**CITY OF ALBANY  
CITY COUNCIL AGENDA  
STAFF REPORT**

**SUBJECT:** Annual Sidewalk Rehabilitation Program (CIP No. 22000)  
Contract No. C23-09 Contract Change Order #1

**CONTRACT:** *Sidewalk Rehabilitation Program Phase 7*  
**Contract No. C23-09**

**PROPOSAL FORM – POTENTIAL CONTRACT CHANGE ORDER #1  
REPAIRS AT 1501 WASHINGTON AND 602 SANTA FE**

# 1612 Solano – Repair Options

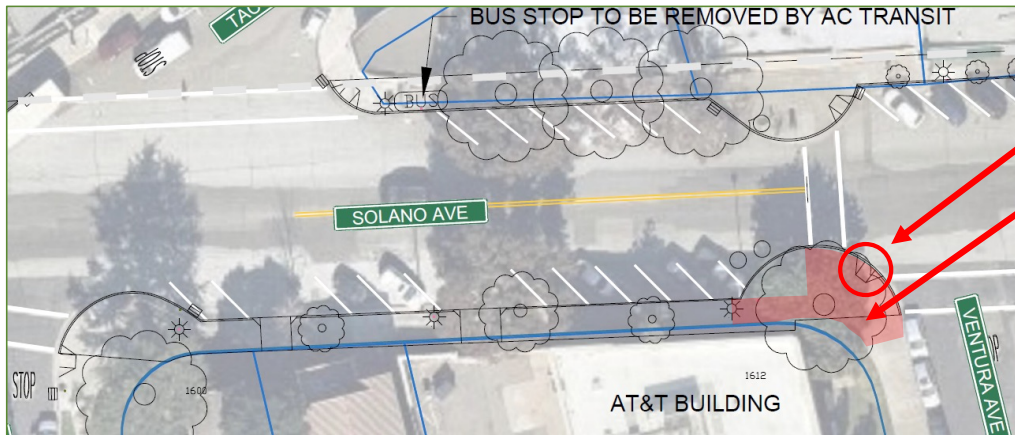
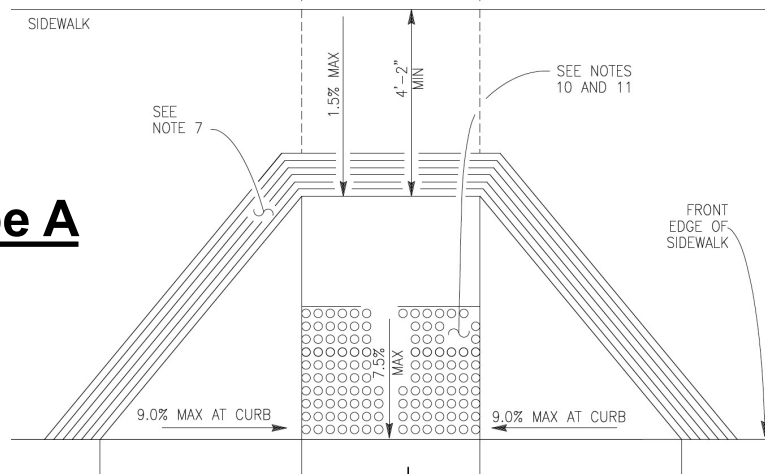
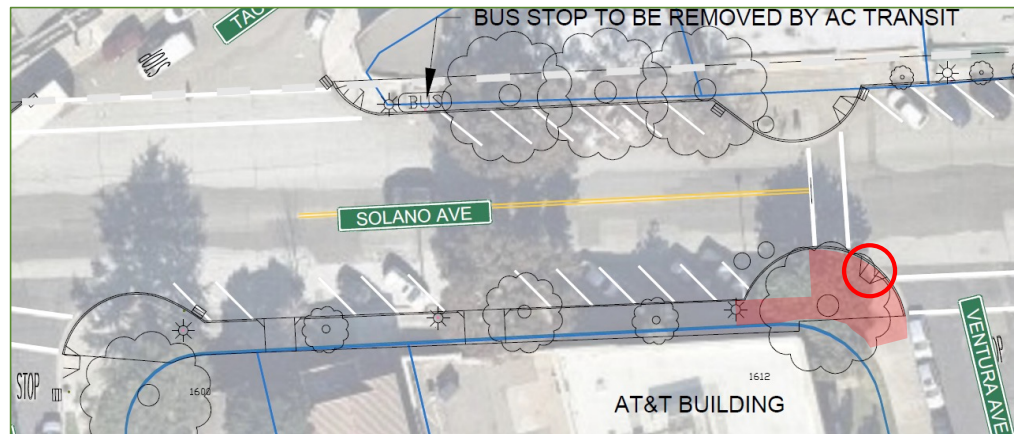
## Option 1 – RECOMMENDED

- Upgrade ramp in-place (Type A)
- Conduct critical repair
- Corridor improvements (incl. 2x directional ramps) at later date with Complete Streets

## Option 2

- Do not conduct critical repair
- Fix critical issue & upgrade curb ramps at later date with Complete Streets construction
- City has interim liability

- Approve 1612 Solano – one (1) curb ramp upgrade in-place (diagonal)

# 1134 Santa Fe Ave

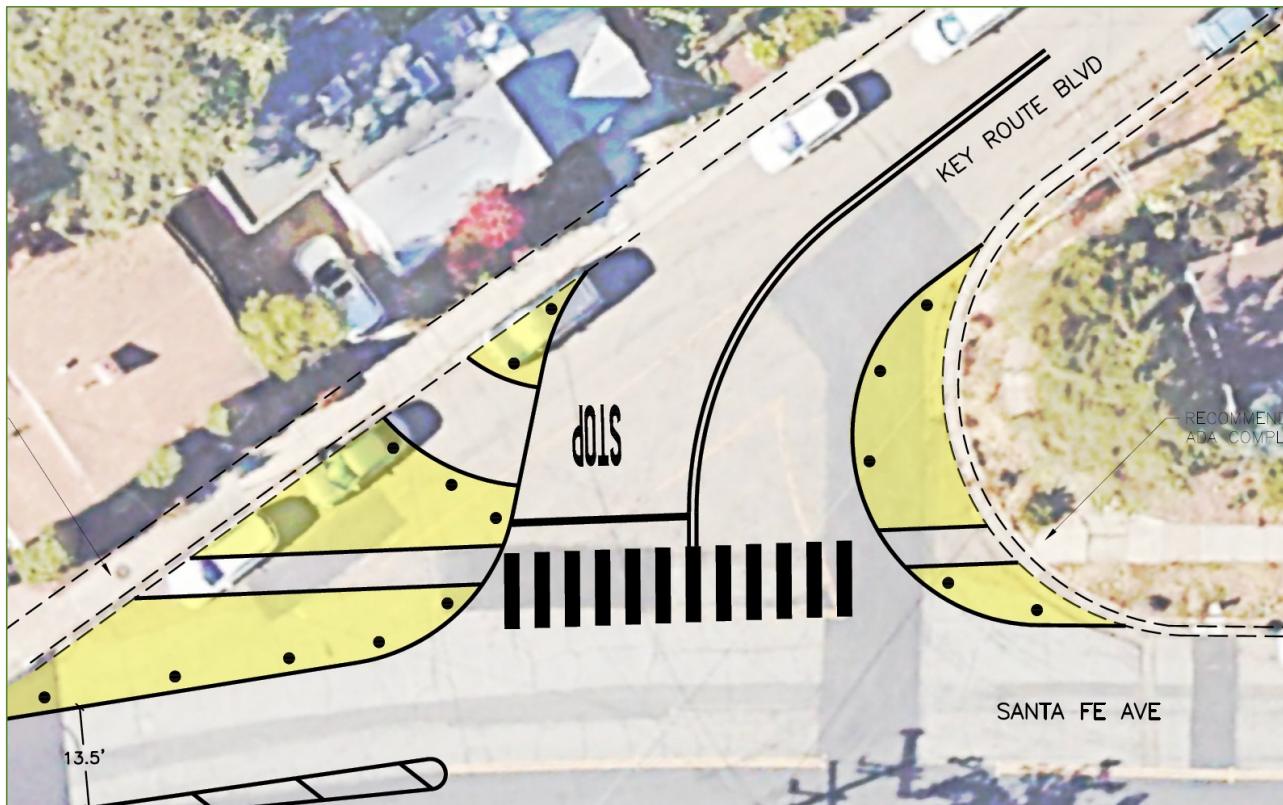
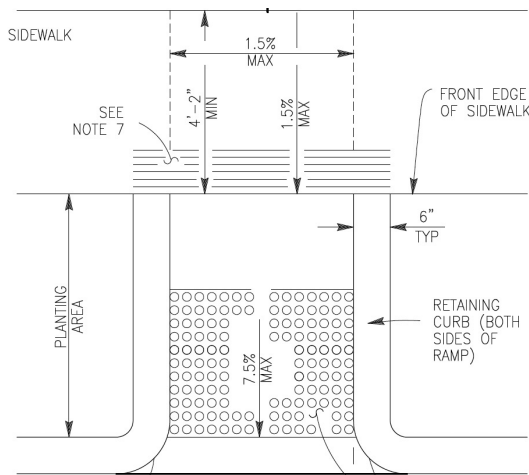
- Critical “No Best Path of Travel” hazard
- Poor conforms and multiple issues require large repair footprint

- Level of repair will trigger curb ramp upgrade

- Repair curb ramp in-place (directional) during Phase 8
- Long-term concrete improvements during paving project
- Long-term to rework curb ramp(s) as needed

- Conduct critical repair
- Upgrade ramp in-place (Type F)
- Ramp in-question will align with quick build improvements

- Approve 1134 Santa Fe – one (1) curb ramp upgrade in-place (directional)

Draft Design – 1501 Washington

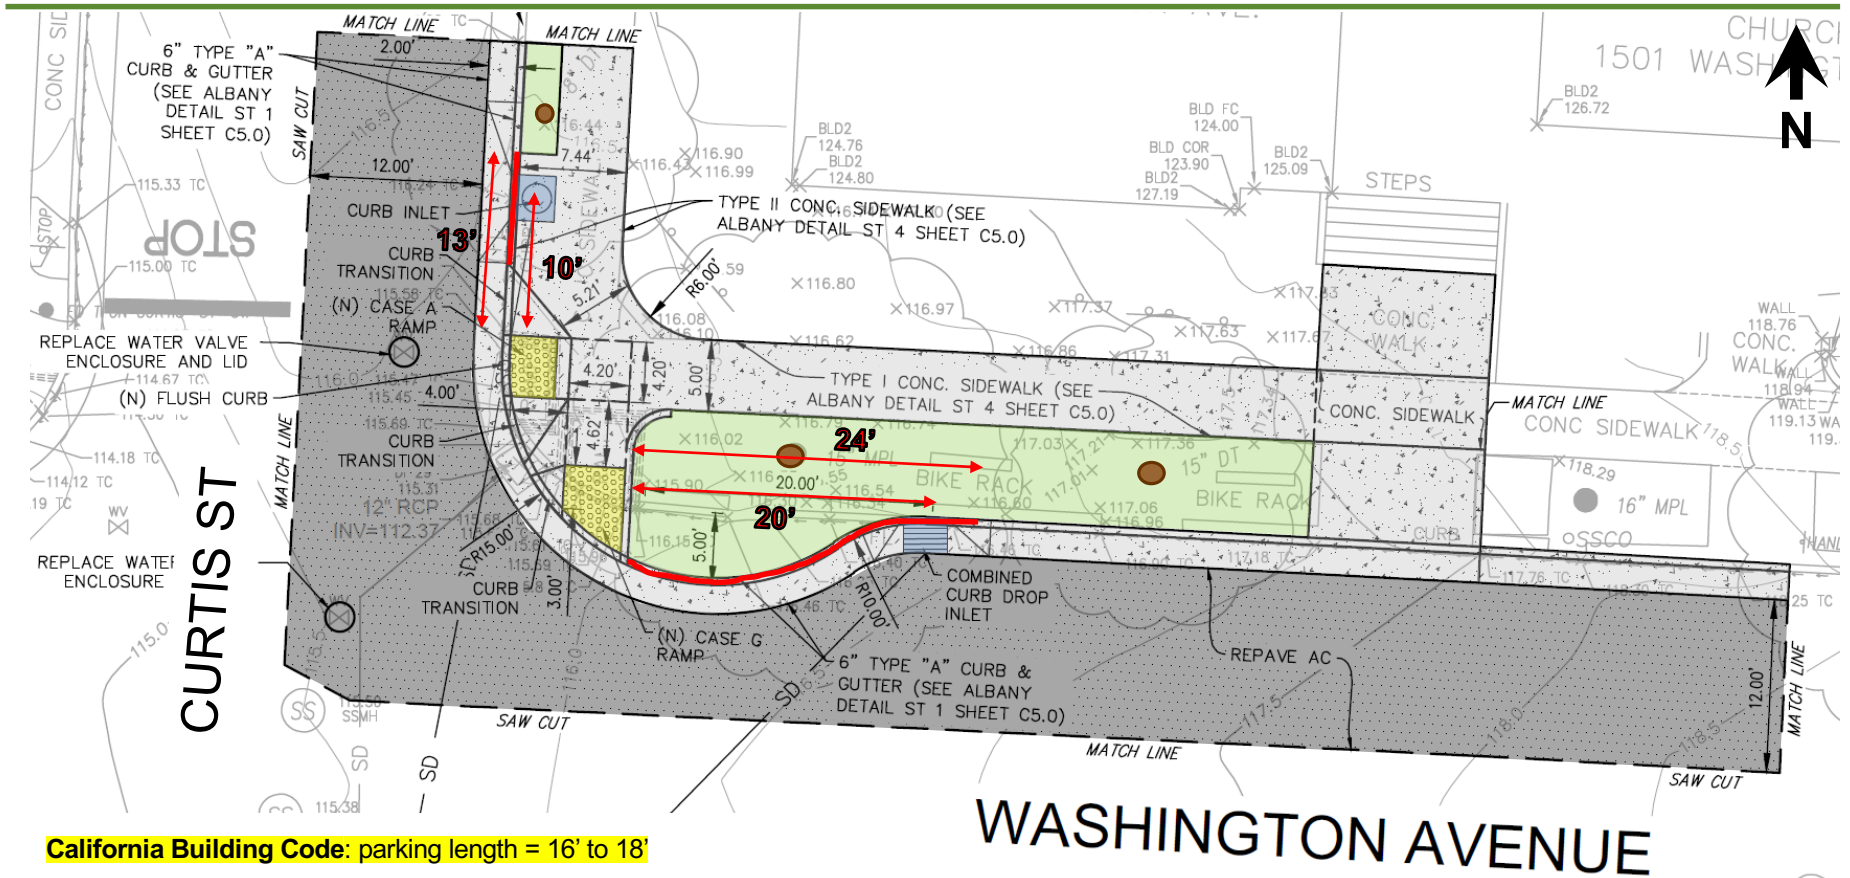
- Street trees (2x liquidambar) damaged sidewalk, curb, and roadway
- Combination of asphalt, curb, & sidewalk work will trigger curb ramp upgrade
  - Two directional curb ramps to be installed
  - Includes bulbout along WB Washington approach
  - Bulbout extends where red curb would be installed (20 lf)
- Expanded landscaping strip / tree well basin
  - Non-City application for removal of adjacent trees (tent. June 2023 Parks, Recreation, & Open Space Commission meeting)

California Building Code: parking length = 16' to 18'

- Approve 1501 Washington Ave design:
  - i. Two (2) curb ramps (directional) with bulbout along Washington
  - ii. Red curb (up to 13' along NE Curtis + up to 24' along NE Washington)
    - Staff to modify red curb to 10' and 20', respectively, if feasible with storm drain relocations
